Summary of I.17-02-002: Workshop #3 Informal Comments

The following is a summary of comments received on August 13, 2020, in response to the July 28, 2020, Aliso Canyon Modeling Results Workshop #3 held remotely. Staff has considered all feedback and suggestions from the written comments and workshop in the responses provided.

## MAXIMUM WITHDRAWAL RATE (MMCFD)

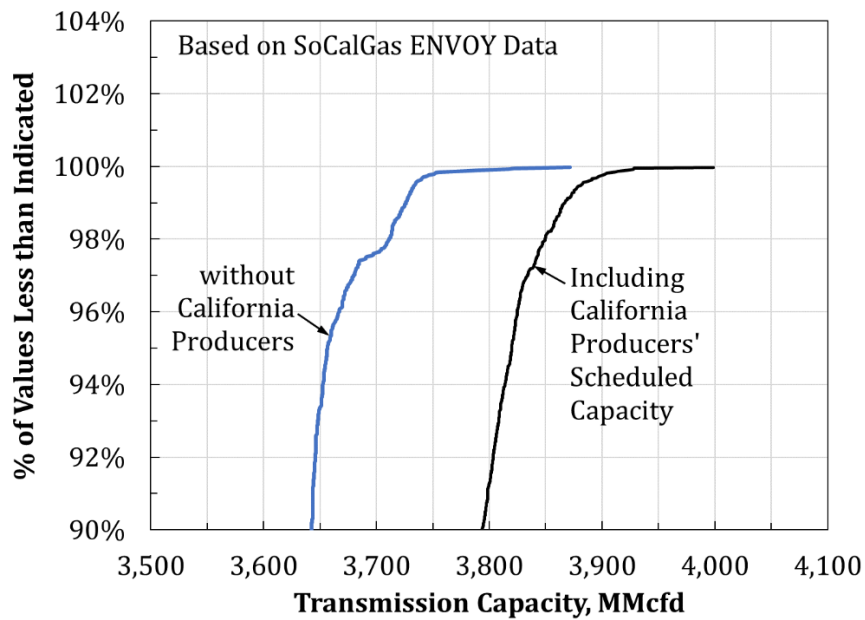
- Slide 12: the maximum withdrawal rates assumed for each of the scenarios vary without explanation. Most importantly, Aliso Canyon withdrawal capacity is omitted from each of the scenarios except winter 2030, and both Aliso Canyon and Honor Rancho are omitted entirely for summer 2030. Slide 12, S05 says Aliso is included to determine the minimum amount needed from Aliso. However, since Aliso is not operating in the other simulations, this slide fails to show the minimum amount needed. Lastly, explain rationale for excluding Honor Rancho in Sim 06.

↑  
S05  
includes  
Aliso  
determines  
minimum  
amount needed  
from Aliso

↑  
S06  
excludes  
Honor  
Rancho  
and Aliso

For the winter simulations (S01, S03, and S05), the same approach could not be used since the first simulation (S01) was a failed simulation and stressing the system more would not have provided any additional insight. For all three winter simulations, an 85% RPU is used for the Northern and Southern Zones and 100% for the Wheeler Ridge Zone. However, due to miscommunication with SoCalGas, S01 RPU was introduced after accounting for the outages resulting in 2,926 MMscfd of supplies, while for S03 and S05, the RPU was applied to the nominal capacity of 3,565 MMscfd resulting in 3,115 MMscfd of supplies. S03 is the key simulation of all three winter simulations because it has the lowest winter demand among the three study years, yet it failed without the use of Aliso Canyon showing that both S01 and S05 would fail without the use of Aliso Canyon. S03 also attempts to bring in more supplies from Otay Mesa, which didn't have much effect on the results compared to S01. Given S03 results, ED and LANL decided that there was no need to repeat S01 with 189 MMscfd additional supplies or to run S05 without Aliso Canyon. Therefore, Aliso Canyon withdrawal was allowed in S05.

4. Please see #3 above. Aliso withdrawal was only allowed in S05. Non-Aliso Inventory levels are at 90% except S04 and S06, where the levels are at 70%.
5. Electric demand forecasts were similar between 2020 and 2022, and between 2025 and 2026. Since Minimum Local Generation results focused on September and December months, Diablo Canyon would already have been retired in
